CONTRACT NO. 1797

OHIO RIVER TUNNEL

**ADDENDUM No. 4**

All bidders bidding **Contract No. 1797** shall read and take note of this **Addendum No. 4**. The Contract Documents for **Contract No. 1797 – Ohio River Tunnel** are hereby revised and/or clarified as stated below.

### ORT O27 UTILITY INSPECTION COVERAGE EXHIBIT

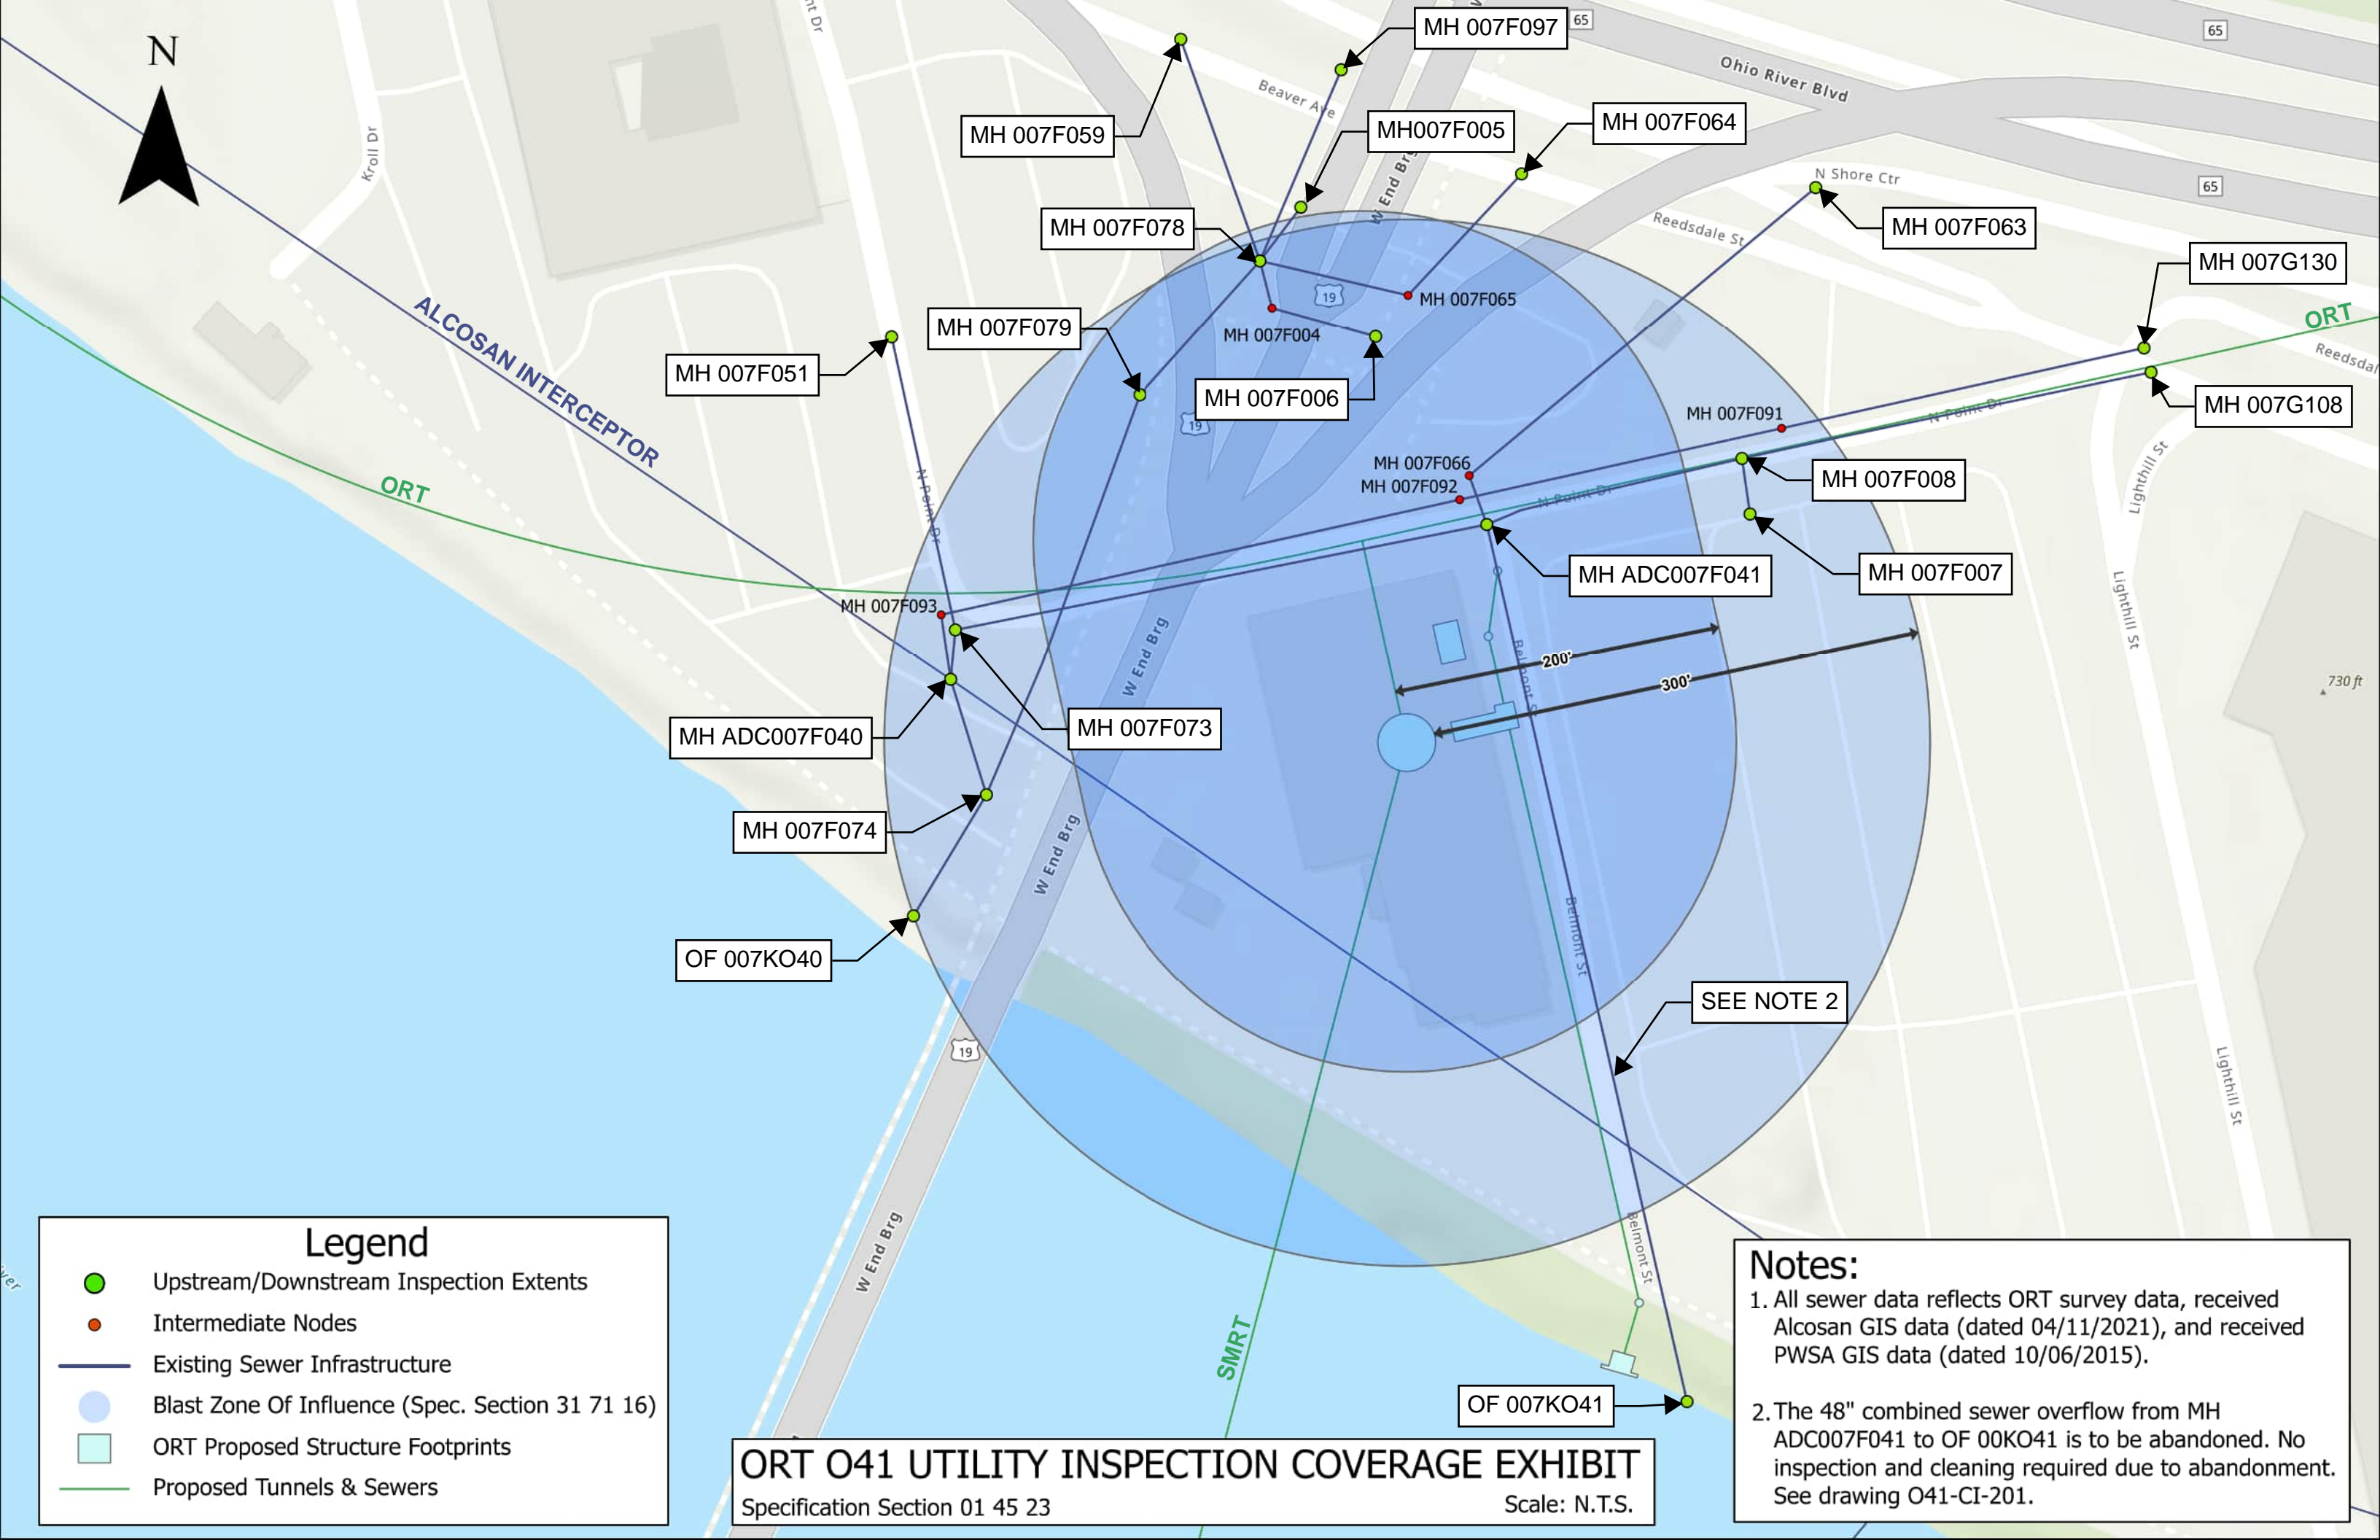
- Contract Drawings do not encompass the full zone of influence depicting all utilities which require internal video surveys. Please provide a comprehensive sewer utility map within the extents of the prescribed Zones of Influence as necessary for Bidders to accurately price the Work.*

- A1      **Replace Specification Section 01-45-23, Attachment 2 in it's entirety with Specification Section 01 45 23, Attachment 2 REVISED 09/25/2025 (see Attachment A of this Addendum). Exhibits have been added to APPENDIX E – SUPPLEMENTAL INFORMATION for each site; (see Attachment B of this Addendum).**

8. APPENDIX E – ADD *Section 10 Utility Inspection Coverage Exhibits* to APPENDIX E Table of Contents (page 8 of 10153). ADD *Utility Inspection Coverage Exhibits* (8 pages) to Section 10, which is Attachment B to this Addendum.
